ERRATA SHEET

Attached please find corrected replacement pages for the Application and Supporting Environmental Report for the USNRC Commercial Source Material License. Please replace the original pages with the corrected pages. These changes were made as a result of the Engineering Design Report for the evaporation ponds by Western Water Consultants, Inc. dated April 27, 1988.

REV	DATE	FERRET OF NEBRASKA, INC.
		CROW BUTTE PROJECT
		Dawes County, Nebraska
		SITE LAYOUT
		PREPARED BY: F.E.N.
		DWN BY: JC DATE: 7/87 FIGURE: 4.2-1

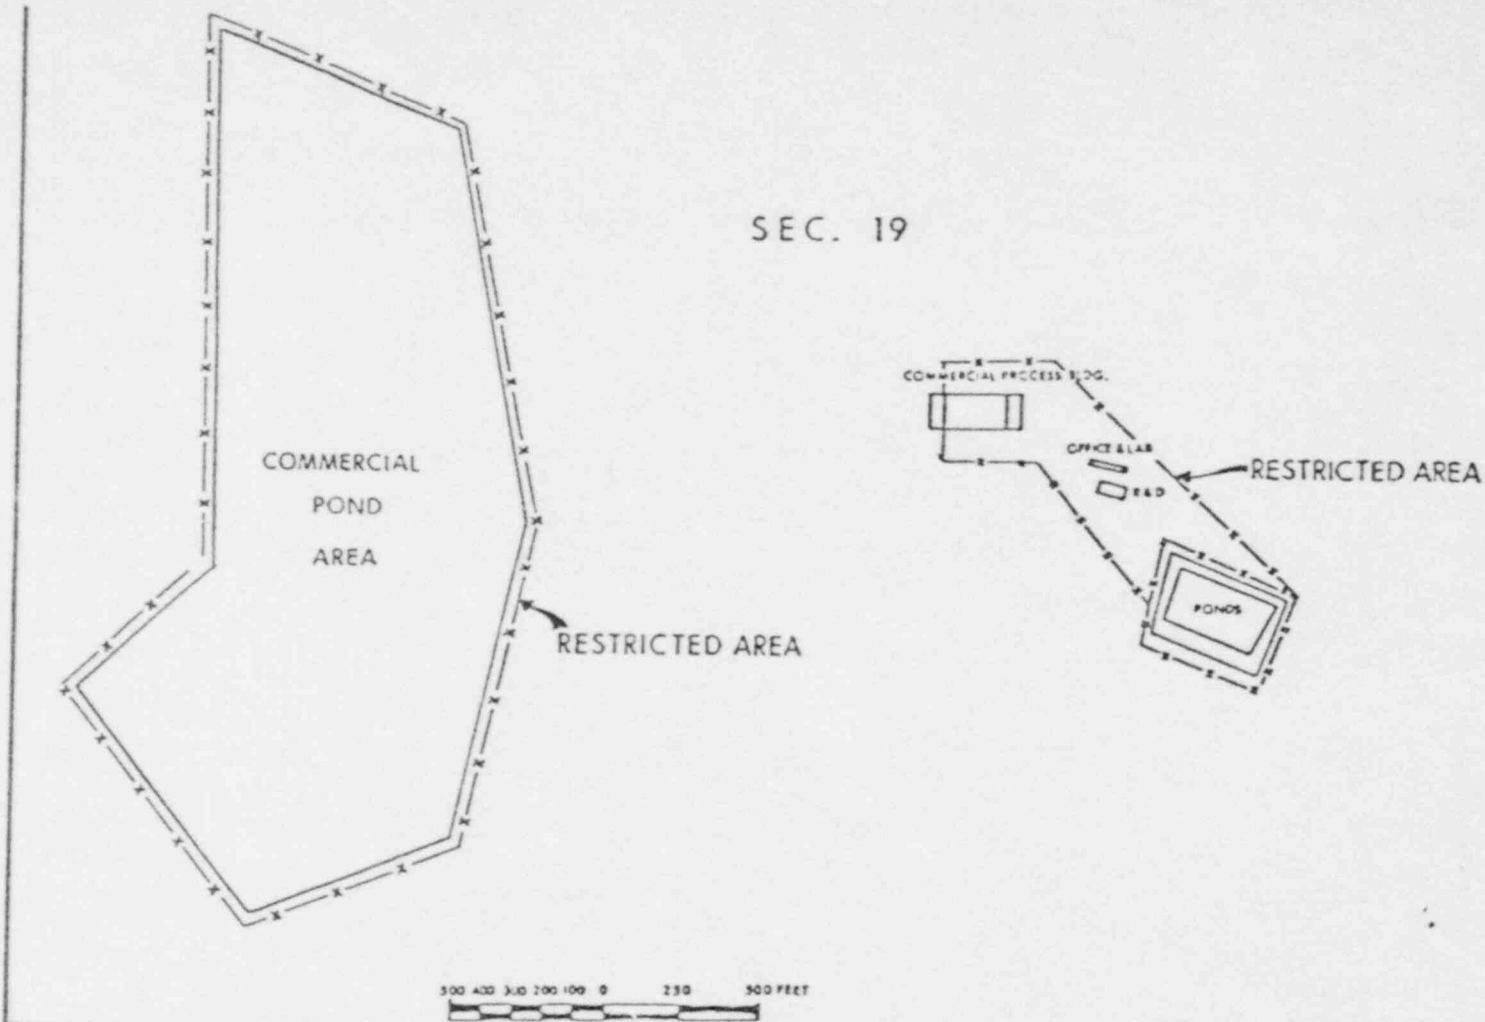
<u>Page No.</u>	<u>Change</u>
3.0(11)	Figure 3.1-6 - Changed to show individual ponds.
4.2(1)	Size and design changes as a result of detailed engineering.
4.2(2)	Change in pond outline.
4.2(3)	Change in capacities as a result of detailed engineering.

FEN plans to install up to a total of five solar evaporation ponds at the Crow Butte Site. The ponds will be nominally 280 feet by 800 feet by fifteen feet in depth. The ponds will be located west of the commercial plant as shown on Figure 4.2-1. Initially FEN plans to install two ponds; additional ponds will be constructed as needed during restoration.

REV DATE	FERRET OF NEBRASKA, INC.	
	CROW BUTTE PROJECT	
	Dawes County, Nebraska	
	SITE LAYOUT	
	PREPARED BY: F.E.N.	
	DWN BY: JC	DATE: 7/87
	FIGURE: 4.2-1

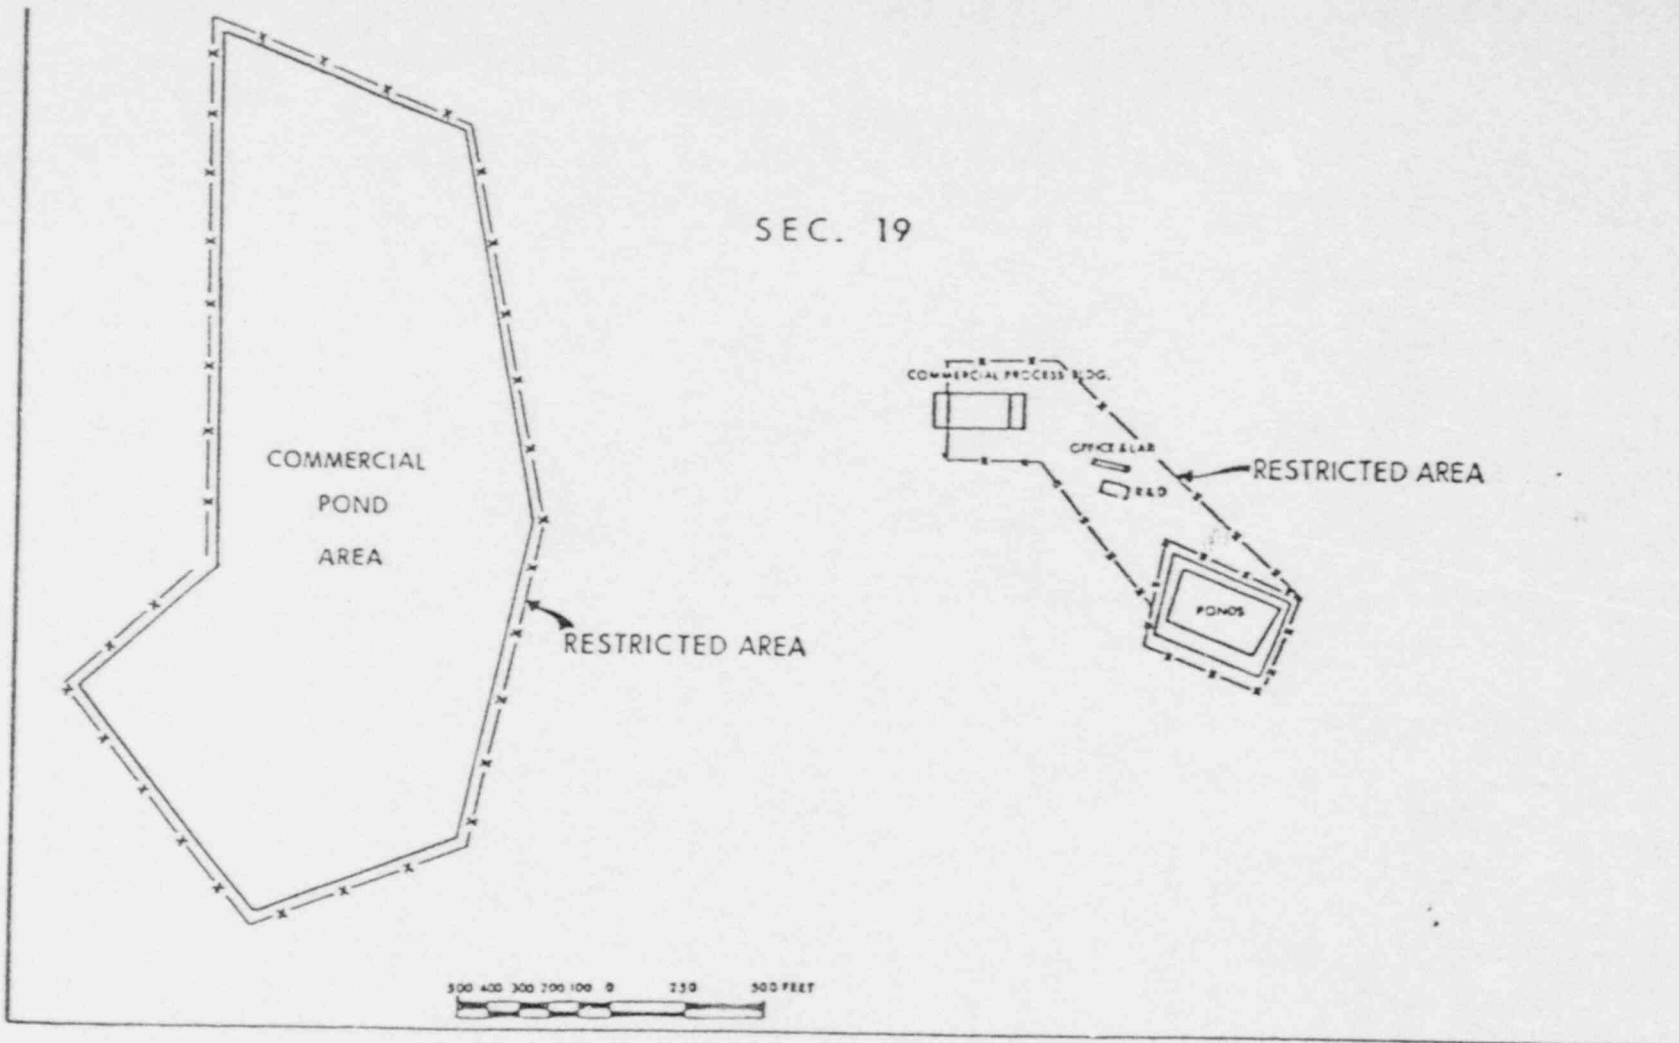
<u>Page No.</u>	<u>Change</u>
3.0(11)	Figure 3.1-6 - Changed to show individual ponds.
4.2(1)	Size and design changes as a result of detailed engineering.
4.2(2)	Change in pond outline.
4.2(3)	Change in capacities as a result of detailed engineering.

FEN plans to install up to a total of five solar evaporation ponds at the Crow Butte Site. The ponds will be nominally 280 feet by 800 feet by fifteen feet in depth. The ponds will be located west of the commercial plant as shown on Figure 4.2-1. Initially FEN plans to install two ponds; additional ponds will be constructed as needed during restoration.
